## TPS61042DRB New package qualified

One of my customers knows that a new package made at TI CDAT assembly site were qualified as an additional package of TPS61042DRB via PCN# 20230719001.1

Package outline drawing:

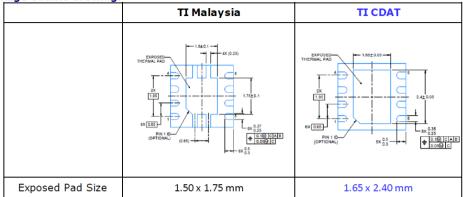
They designed TPS61042DRB foot pattern on their PCB by copying example board layout on page 27 of the device datasheet. Their stencil design is same. It was designed by copying example stencil design on page 28 of the datasheet.

They think that remained solder of pattern "A" would become solder ball when the package made at TI CDAT is soldered without PCB footpattern changing and they worry that this solder ball would cause any trouble.

What do TI think about this? They want to hear TI thought.
